## DEVIATION REQUEST AND DECISION FORM

Project Name : 2104 LLC SITE DEVELOPMENT PLAN  
Schedule No.(s) : 6429101011, 6428201008  
Legal Description : SEE ATTACHED – Exhibit B

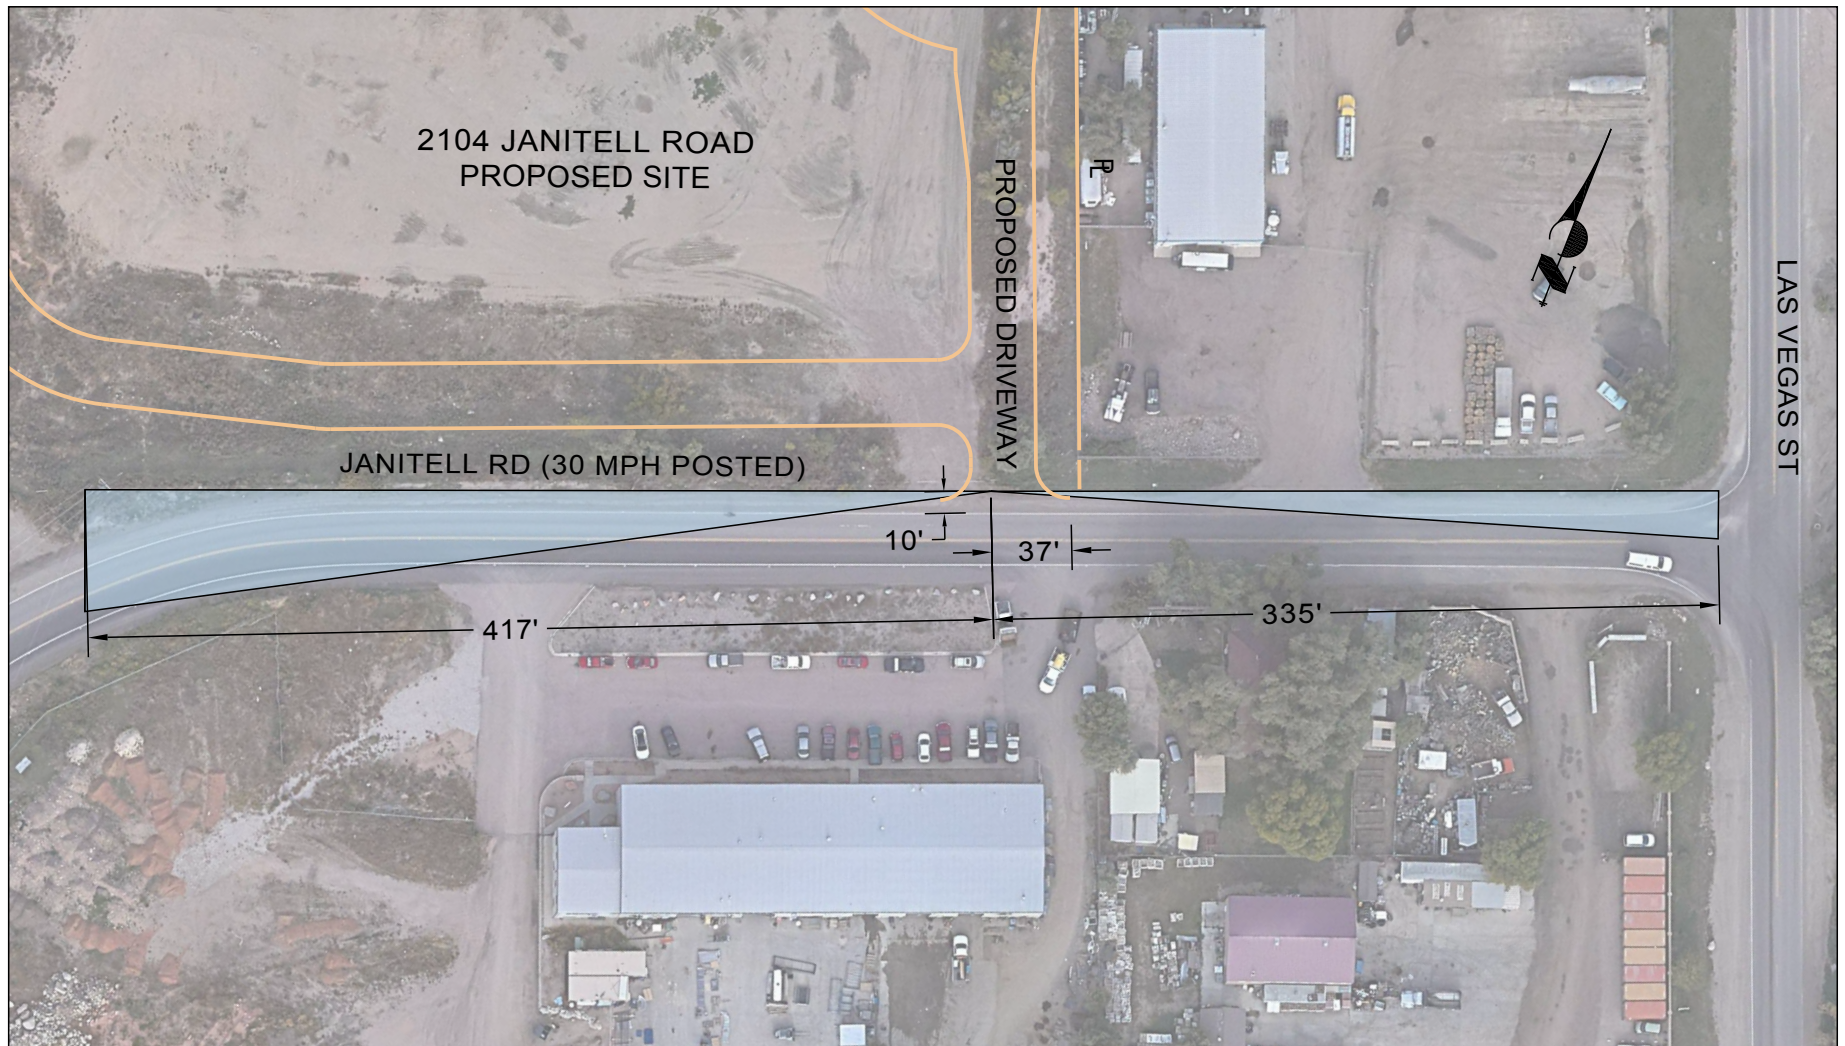
As discussed with the design engineer regarding review 3 comments, a deviation request would only be considered if there is sufficient justification why the driveway can't be located to the southwest to meet criteria. The sight distance appears to be met if the driveway is located at the southwest area of the project (see the snippet below). At this time Staff's recommendation would be to deny the deviation request.

Update the deviation request to provide an explanation that staff may be unaware of that precludes having the driveway at the southwest area of the project or else revise the site plan.
